## **Wood Acres Elementary School, Mandatory Referral, MR2014044**

**Date of Staff report: 07-01-14**

**SUBJECT:** Woodacres Elementary School Mandatory Referral - MR2014044

Re: Stormwater Management **CONCEPT** Request  
for Wood Acres Elementary School  
SM File #: 263655  
Tract Size/Zone: 4.78 Ac./R-60  
Total Concept Area: 1.96 Ac.  
Parcel(s): P935, N954, P880  
Watershed: Little Falls Branch

# Proposed Site Plan

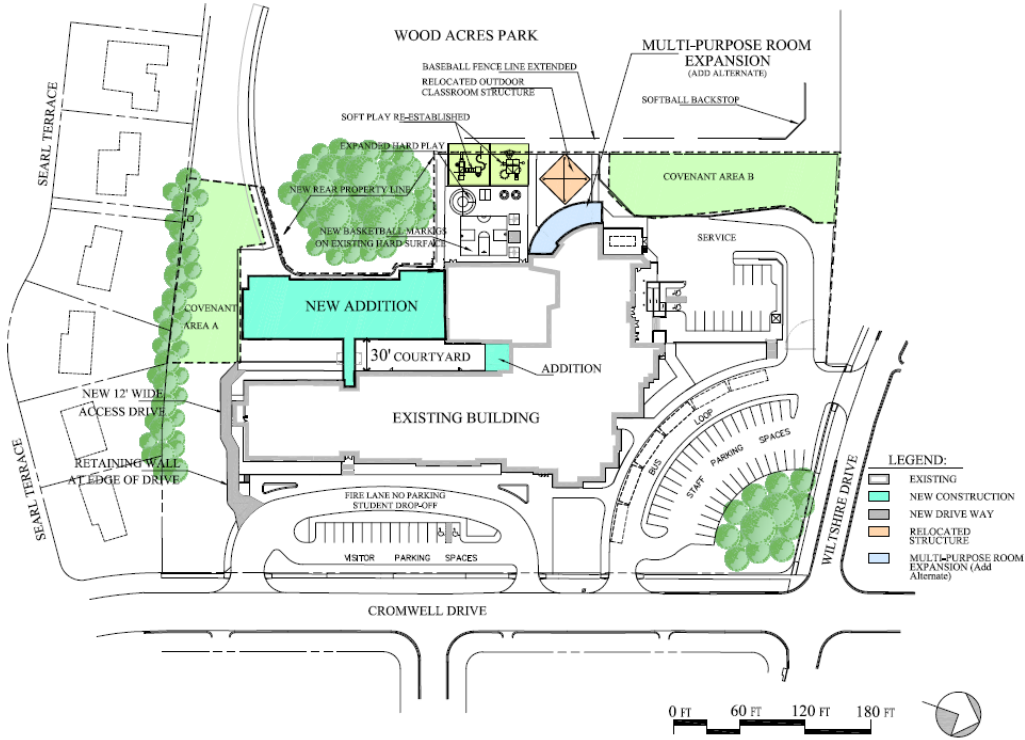
1. MCPS must get a Park Construction Permit for any construction, or construction related activity on parkland.
2. The 36" diameter Northern Red Oak (Tree # 28 on the FCP exemption Plan 42014104E) located near the existing retaining wall will be retained. The Park Department's tree crew will prune the tree for construction clearance and remove deadwood. This work should be coordinated with the start of construction in January 2015 so the Park's tree crew can have access to the tree from MCPS property.

3. The Parks Department will also improve tree health by improving soil conditions within the critical root zone of this tree through soil decompaction and application of cultural treatments. The result is swale grading as shown should be eliminated. In place of the swale grading, MCPS to provide a 1 foot wide trench directly behind the existing retaining wall to move water to the proposed inlets. All work within the critical root zone of this tree should be done by hand with no equipment access.

4. MCPS will shift the proposed stairs to the corner of the retaining wall. The result of moving the stairs will lessen the impact on the existing 25" Northern Red Oak (Tree # 26) and minimize impacts to this tree. This will result in increased impacts within the critical root zone the 25"/14" tulip poplar (Tree #27). Due to this impact and current condition, this tree will be removed by Park Department's tree crews at start of construction.

5. The Limit of Disturbance (LOD) as shown now is excessive on park property in the area of the trees behind the existing retaining wall. The LOD should be revised based on the above comments so that the LOD provides enough space for the work, but no equipment access in the critical root zone of the trees.

RESPONSE: This will be coordinated at the start of construction, and a note will be added to the plans.

RESPONSE: The plans will be revised to incorporate a trench directly behind the existing retaining wall in lieu of the swale. A note will be added to the plans to state that all work within the CRZ shall be done by hand.

RESPONSE: The plans will be revised to shift the proposed stairs to the corner of the retaining wall in order to lessen the impact on existing trees.

RESPONSE: The LOD will be revised on the plans per the above comments to reduce impact to Parks property. A note will be added to state that there will be no equipment access in the CRZ of existing trees.
